**Response to Government Departments Comments on
Application Number A/NE-TKP/1**

S16 Application:

**Proposed Temporary Private Garden for a Period of 3 Years on Government Land Adjoining
Lot No. 369 in D.D. 255**

Figure A: A plan showing the area of the raised platform, including both the existing raised platform and the proposed new raised platform area. The Plan also shows the range of height difference from the edge of the proposed new raised platform area and the proposed temporary garden land level.

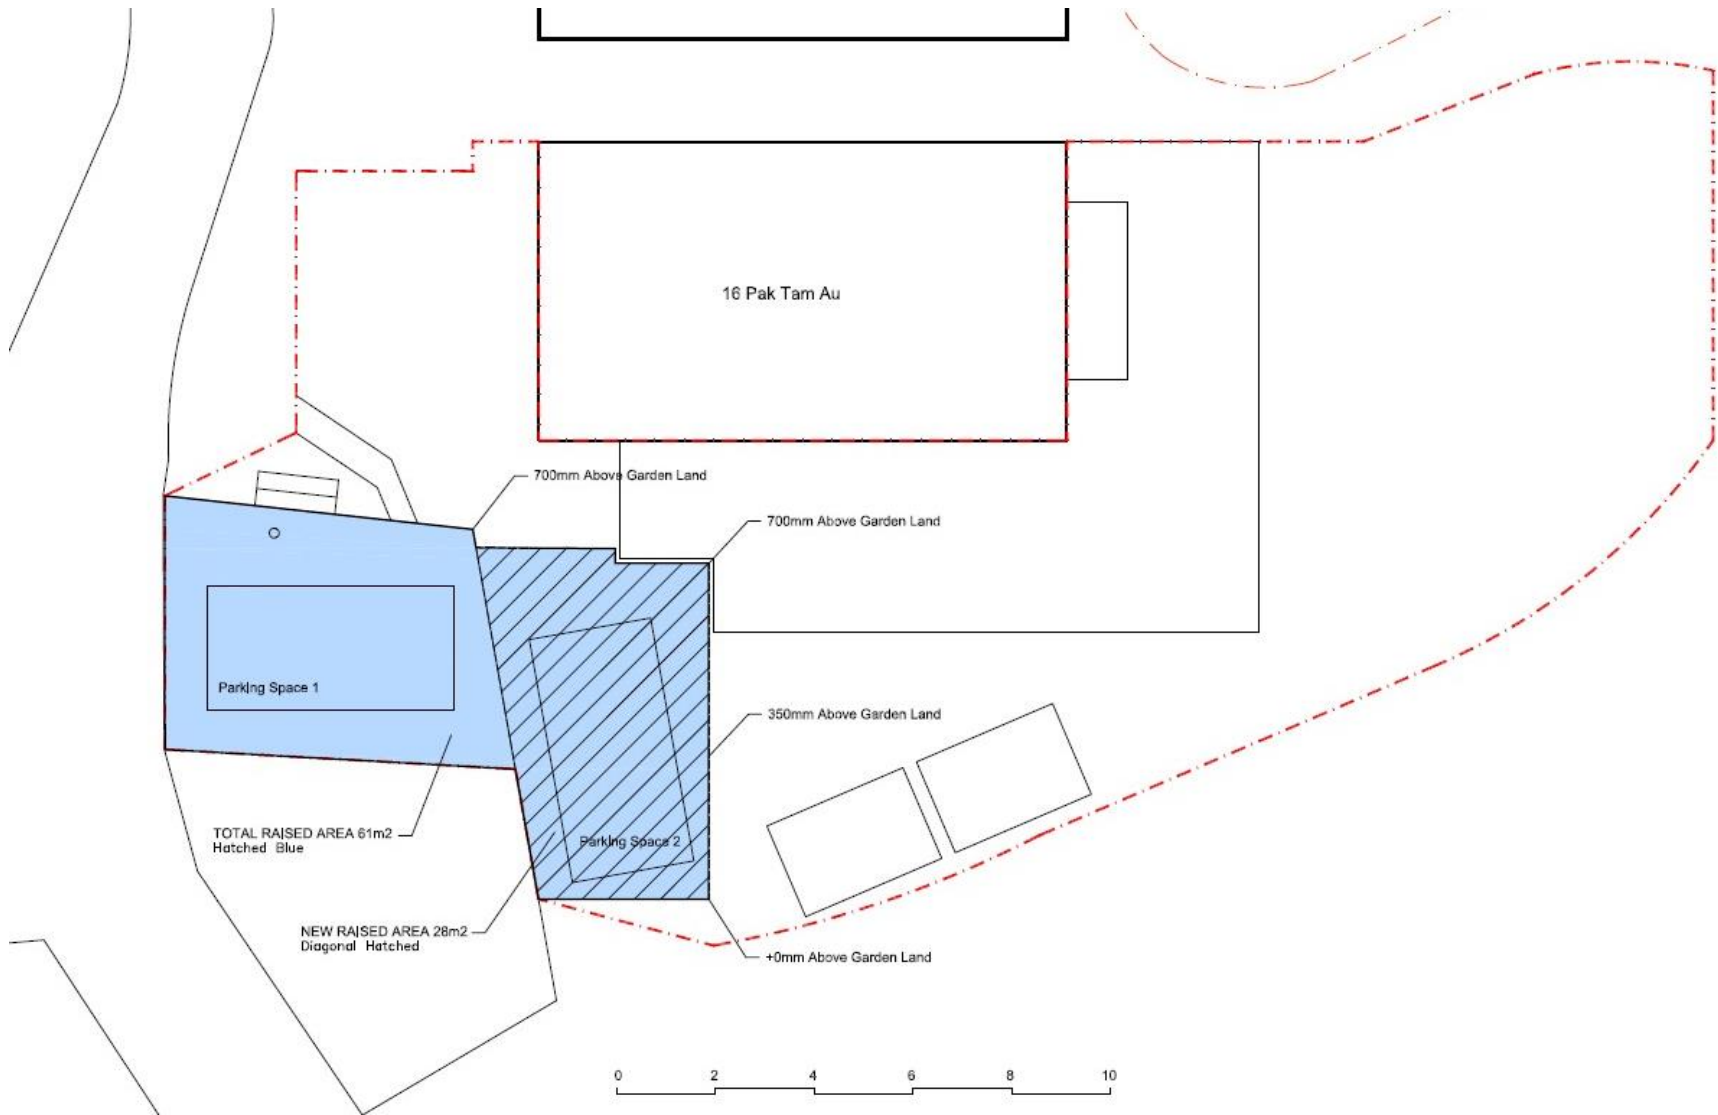
3.	Please advise the total area of raised platform (including the existing platform within the application site and the additional part after proposed filling of land (i.e. 28m ²)) and mark the area of existing platform on figure/plan in scale.	The total area of raised platform is 61 m ² . It is shown in Figure A . This plan indicates the total area of the raised platform as well as the location of the proposed additional part of the raised platform. The additional part of the raised platform will be 28 m ² .

4.	Please advise the range of level difference between the proposed raised platform and remaining part of the proposed temporary private garden.	The range of level difference between the proposed raised platform and the remaining part of the proposed temporary garden is 700mm-0mm. The range of level difference is shown in the scale drawing attached in Figure A . Figure B shows a section of the proposed raised platform.

Figure C: A revised Figure 3 from the Planning Statement, to scale and dimensions.

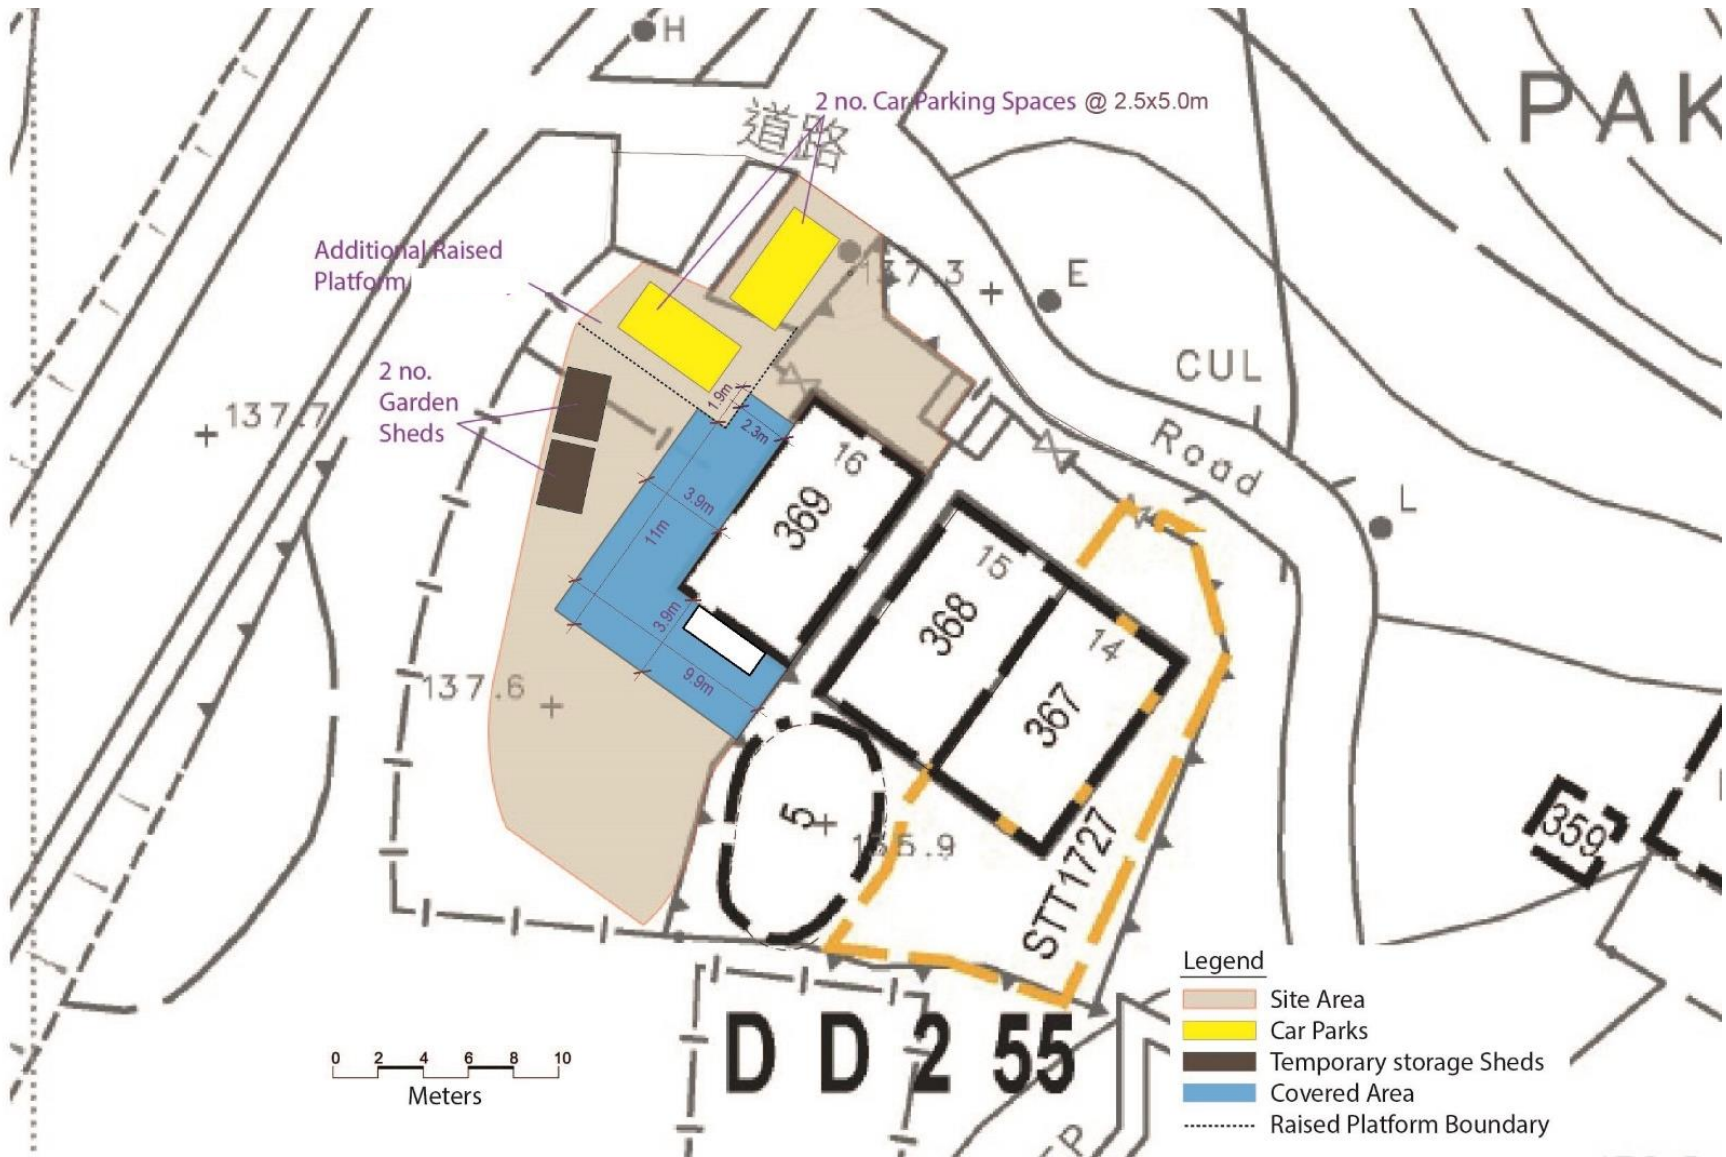
7.	Noted that height of covered area is about 2.56m, please also advise the width and length of the covered area by marking on figure/plan in scale.	Please see the revised scale drawing showing the dimensions. Please see Figure C .

Comment	Response
1.	The size of private car parking spaces shall be 2.5m x 5m each. The application shall mark the parking spaces on plan in correct scale.	Please find the updated plan showing the parking spaces in scale with dimensions of 2.5m x 5m each, shown in Figure C .
